[2] REDLINE REVISION NO. 2 — MAY 2012
TEDD APPROVAL — SHA NO. XX6475185

[1] REDLINE REVISION NO. 1 — MARCH 2012
ORIGINAL ON FILE
TEDD APPROVAL — SHA NO. XX6475185

MD 174 (QUARTERFIELD ROAD) AT
PAMELA ROAD /LANDMARK DRIVE
HANOVER, MARYLAND

SIGNALIZATION PLAN SHEET

2 SE CORNER - NOT TO SCALE

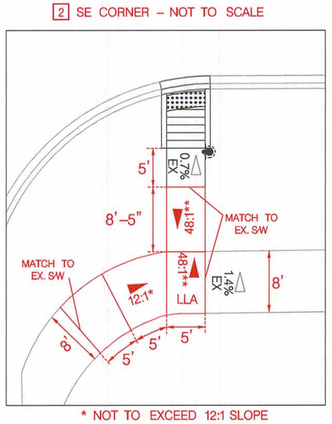
M. REMOVE EXISTING PAVEMENT MARKINGS THAT EXTEND PAST THE PROPOSED STOPLINE AND WITHIN THE PROPOSED CROSSWALK.
N. USE EXISTING CONDUIT.
O. CONSTRUCT 5 IN. CONCRETE SIDEWALK (5 FT. WIDE).
[1] P. REMOVE EXISTING 12:1 SIDEWALK RAMP SECTION AND CONSTRUCT NEW 12:1 SIDEWALK RAMP SECTION (SEE DETAIL THIS SHEET).
[1] [2] Q. REMOVE EXISTING SIDEWALK AND CONSTRUCT NEW SIDEWALK (SEE DETAIL THIS SHEET).
[2] R. REMOVE PREVIOUSLY INSTALLED SIDEWALK AND RAMP AND CONSTRUCT NEW SIDEWALK AND RAMP WITH DETECTABLE WARNING SURFACE PER MD STD. 655.40 (SEE DETAIL THIS SHEET).

2 NE CORNER - NOT TO SCALE

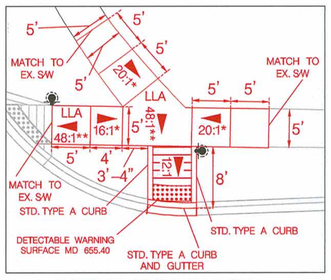
J. INSTALL 24 IN. WHITE PREFORMED THERMOPLASTIC PAVEMENT MARKING LINES FOR STOPLINE.
[1] ~~K. REMOVE EXISTING SIDEWALK AND RAMP. CONSTRUCT NEW SIDEWALK AND RAMP PER SHA STD. MD 655.11.~~
[1] ~~L. REMOVE EXISTING SIDEWALK RAMP AND~~ CONSTRUCT NEW SIDEWALK RAMP WITH DETECTABLE WARNING SURFACE PER MD STD. 655.40 (SEE DETAIL THIS SHEET).
